Preliminary Plat
The Hub at Saratoga Springs
August 13, 2020
Public Meeting

Staff Report

Author: Gordon Miner, City Engineer
Subject: The Hub – Preliminary Plat
Date: Aug 13, 2020
Type of Item: Preliminary Plat Approval

APPLICATION REVIEW CHECKLIST

THE HUB AT SARATOGA

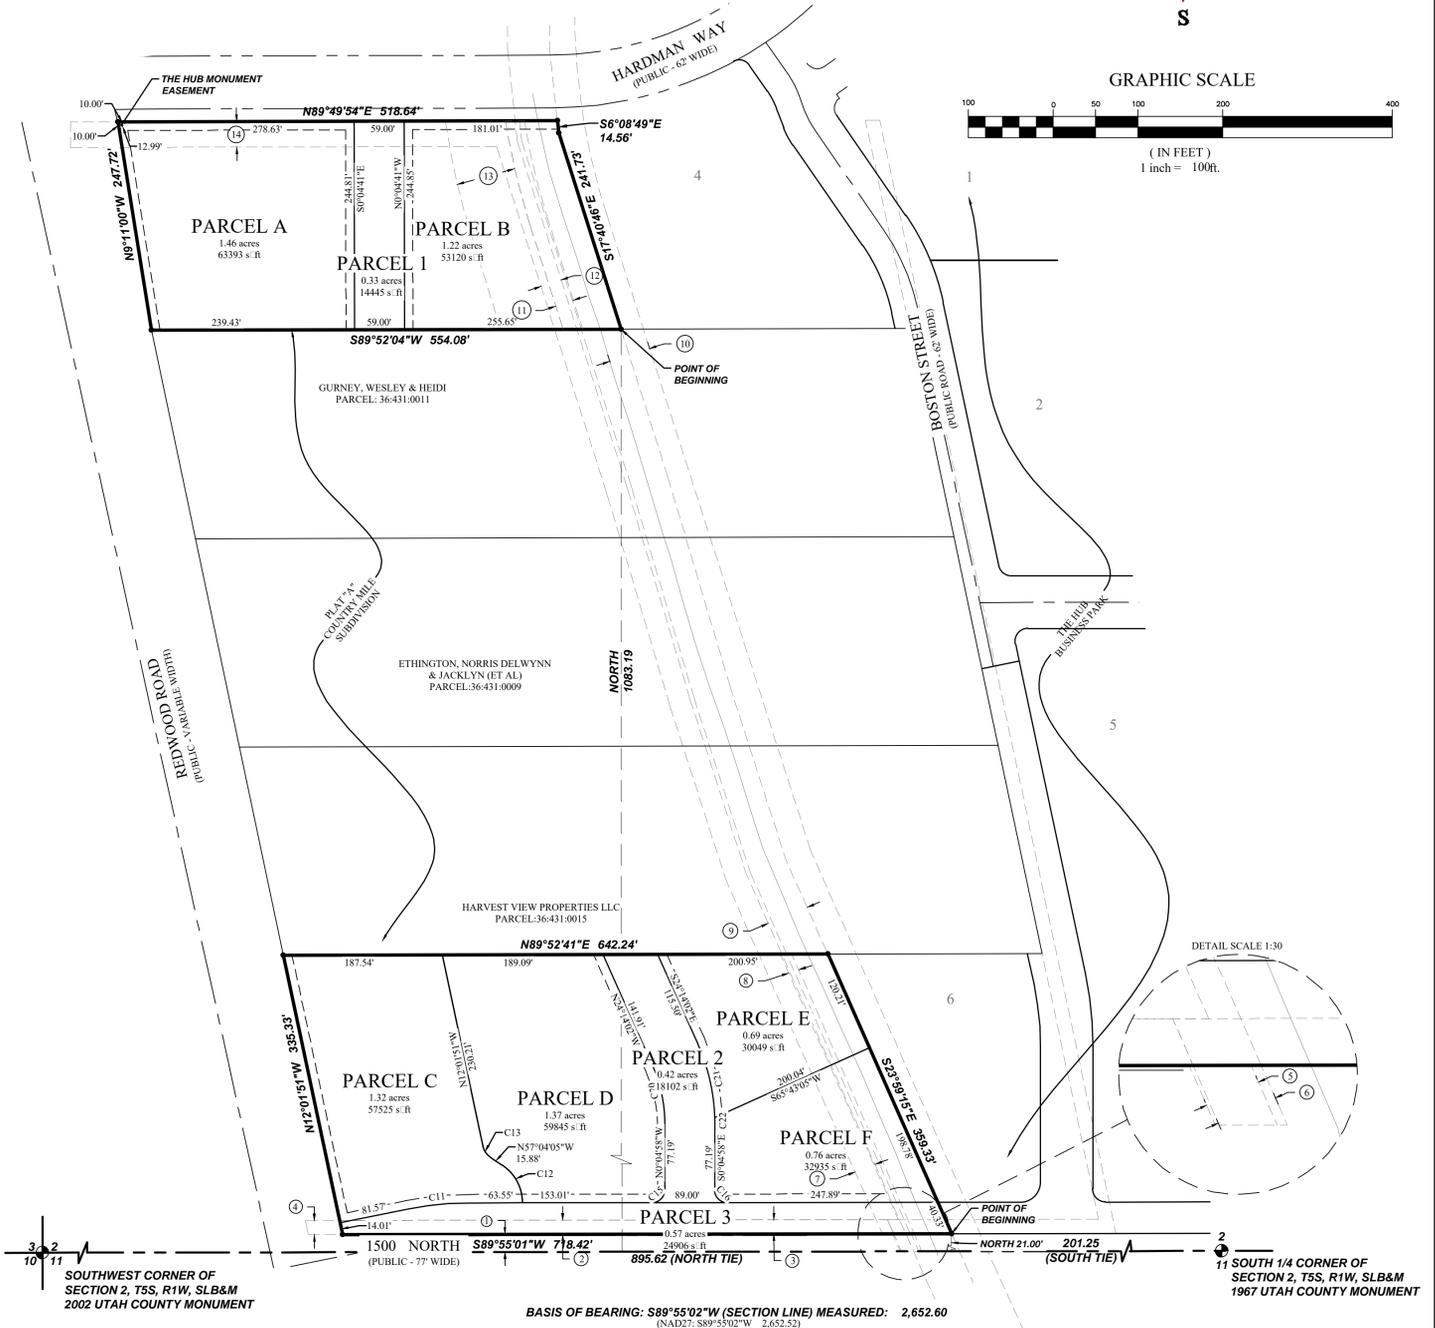
Phasing Plan: Including a data table with the following Information for each phase: i. Subtotal area in square feet and acres; ii. number of lots or dwelling units; iii. open space area and percentage; iv. utility phasing plan; v. number of parking spaces; vi. recreational facilities to be provided; vii. overall plan showing existing, proposed, and remaining phases.	N/A.	
Final Plat Requirements		
Subdivision name and location.	Complies.	
Standard Plat Format followed.	Complies.	
Name and address of property owner and developer.	Complies.	
Name of land surveyor.	Complies.	
The location of proposed subdivision with respect to surrounding property and street.	Complies.	
The name of all adjoining property owners of record, or names of adjoining developments.	Complies.	
The names and location of ROW widths of adjoining streets and all facilities within 100' of the platted property.	Does Not Comply.	<i>Add the street names</i>

North arrow.	Complies.	
A tie to a permanent survey monument at a section corner.	Complies.	
The boundary lines of the project with bearings and distances and a legal description with total project area in SF and acres.	Complies.	
Layout and dimensions of proposed lots with lot area in square feet and acres. Lot boundaries shall include dimensions and bearings.	Complies.	
Lot Numbers.	Can Comply.	<i>Change parcel to lot</i>

Location, dimensions, and labeling of roads, structures, irrigation features, drainage, parks, open space, trails, and recreational amenities.	Can Comply.	<i>Label roads as such</i>
Location of prominent natural features such as rock outcroppings, woodlands, steep slopes, etc.	N/A.	
Proposed road ROW widths.	Complies.	
Vicinity map.	Complies.	
All required signature blocks are on the plat.	Complies.	
Prepared by a professional engineer licensed in Utah.	Complies.	
Proposed methods for the protection or preservation of sensitive lands.	Complies.	
Fencing plans.	N/A.	
Location of any flood plains, wetlands, and other sensitive lands.	Complies.	
Flood plain boundaries as indicated by the Federal Emergency Management Agency as well as the location of 100-year high water marks of all lakes, rivers, and streams.	N/A.	
Existing and Proposed easements.	Can Comply.	<i>Add a public access easement for the canal trail</i>

Street monument locations.	Complies.	
Lot and road addresses and addresses for each intersection. Road names shall be approved by the City GIS department before being added to the subdivision plat.	Can Comply.	<i>Get addresses from GIS</i>
A data table. <ol style="list-style-type: none"> 1. total project area; 2. total number of lots, dwellings, and buildings; 3. where buildings are included, square footage of proposed building footprints and, if multiple stories, square footage by floor; 4. for multi-family developments, the number of proposed garage parking spaces and number of proposed total parking spaces; 5. percentage of buildable land; 6. acreage of sensitive lands and percentage sensitive lands comprise of total project area and open space area; 7. area and percentage of open space or landscaping; 8. area to be dedicated as right-of-way (public and private); 9. net density of dwellings by acre (sensitive lands must be subtracted from base acreage). 	Can Comply.	<i>Add the data table</i>

THE HUB AT SARATOGA
SARATOGA SPRINGS
LANDSCAPE PLAN

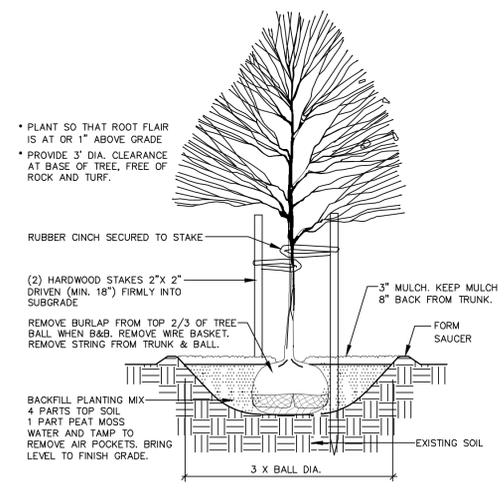
Regulation	Compliance	Findings
Landscape Architect: Landscaped plans shall be prepared by a licensed landscape architect.	N/A.	<i>This plan only has parkstrip landscaping along Redwood Road</i>
Existing Conditions: Show the location and dimension of all existing and proposed structures, property lines, easements, parking lots, power lines, rights-of-way, ground signs, refuse areas, and lighting.	Complies.	
Planting Plan: Show location and planting details for all proposed vegetation and materials. Indicate the size of the plant material at maturation. All existing vegetation that will be removed or remain must be identified.	Complies.	
Plants: The name (both botanical and common name), quantity, and size of all proposed plants.	Complies.	
Topography: Existing and proposed grading of the site indicating contours at two-foot intervals.	Complies.	
Irrigation: Irrigation plans showing the system layout and details.	Does Not Comply.	<i>No irrigation plan provided</i>

Evergreens: Evergreens shall be incorporated into landscaped treatment of sites where screening and buffering are required.	N/A.	<i>This will be reviewed with each site plan</i>
Softening of Walls and Fences: Plants shall be placed intermittently against long expanses of building walls, fences, and barriers to create a softening effect.	N/A.	<i>This will be reviewed with each site plan</i>
Planting and Shrub Beds: Planting and shrub beds are encouraged to be used in order to conserve water.	N/A.	<i>This will be reviewed with each site plan</i>
Water Conservation: Water-conserving sprinkler heads and rain sensors are required. Drip lines should be used for shrubs and trees.	Can Comply.	<i>Provide an irrigation plan and meet this requirement</i>
